TECHNICAL SERVICE BULLETIN

DATE ISSUED	MODEL YEAR(S) AFFECTED	TSB #
04/14/2015	2014-2015	TSB 414 Recall # 15V-061

RSB15-330-001

SUBJECT: Meritor Wabco – Double Check Quick Release Valve.

FIG. 2-1

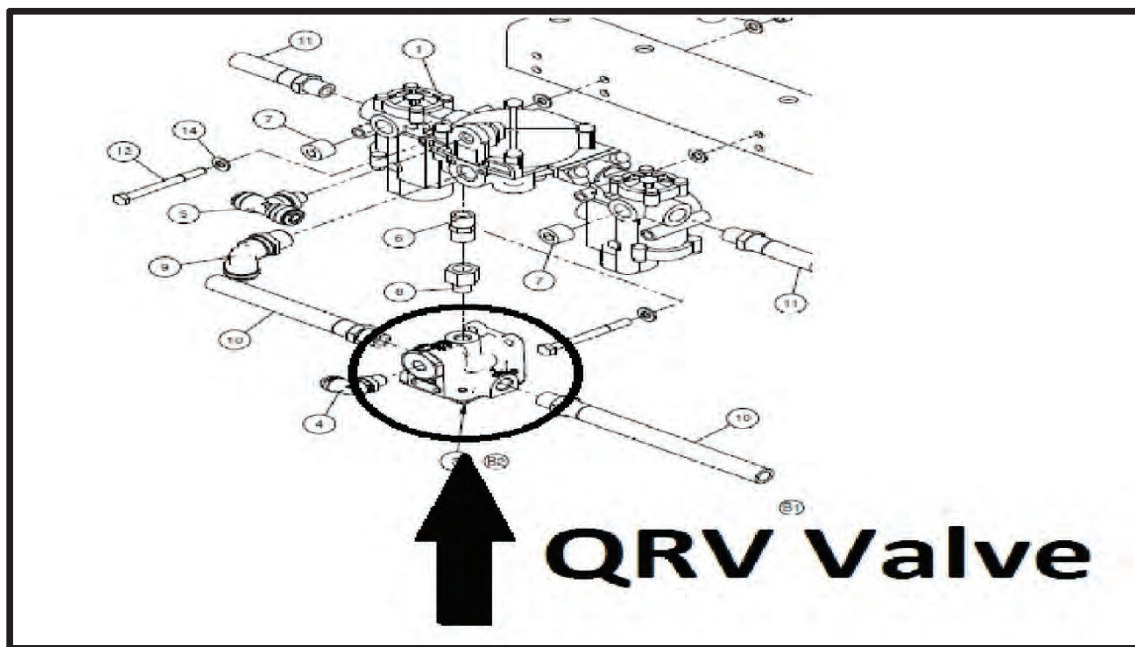
- Drain system air pressure by pulling air tank lanyards or pumping the air brake pedal.
- Locate QRDC valve. QRDC valve is attached to the drive axle ABS modulator assembly mounted to the cross member in front of the drive axle. Refer to FIG. 2-1.

FIG. 3-1

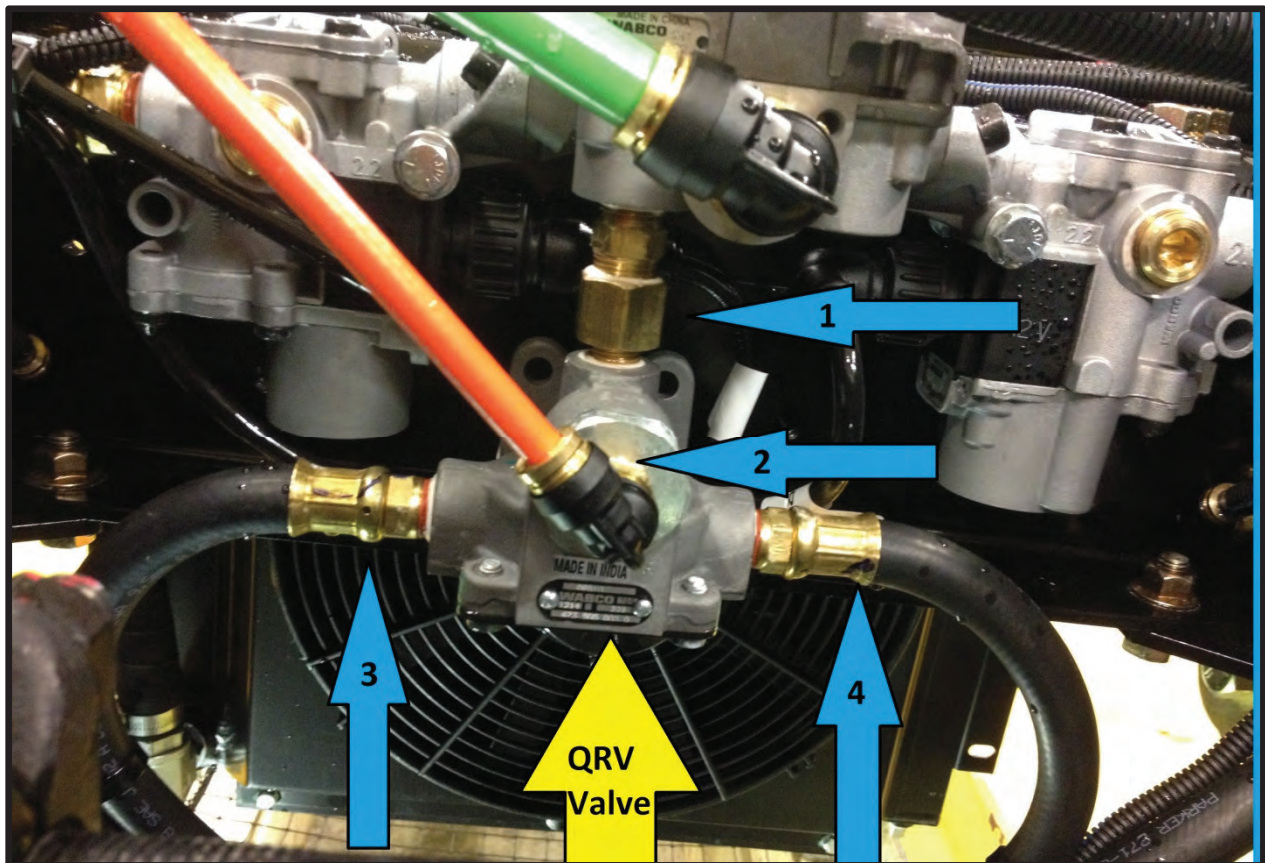
- Using FIG. 3-1 as a guide remove save the following:
 - Brake chamber drop hoses (labeled 3 and 4).
 - Cut cable ties holding ABS sensor cable to drop hoses.
 - Loosen and remove drop hose from brake chamber on both sides (this allows the hose to spin out of the QRDC valve).
 - Loosen and remove the drop hoses from the QRDC valve.
 - Park brake supply line and fitting (labeled 2).
 - Keep orange airline seated in fitting and remove fitting from QRDC valve.
 - ABS to QRDC connect fitting (labeled 1).

- Using an end wrench spin out the QRDC valve from the ABS modulator body (retain brass fittings for new QRDC valve).
4. Install new provided QRDC valve in reverse order, apply 81801 pipe sealer w/Teflon or equivalent to drop hoses, park brake supply fitting and ABS modulator to QRDC valve fitting threads on the first five threads from end.
 5. Run coach to build up system air pressure and check for the following:
 - Park brake operation.
 - Leaks at the QRDC valve.
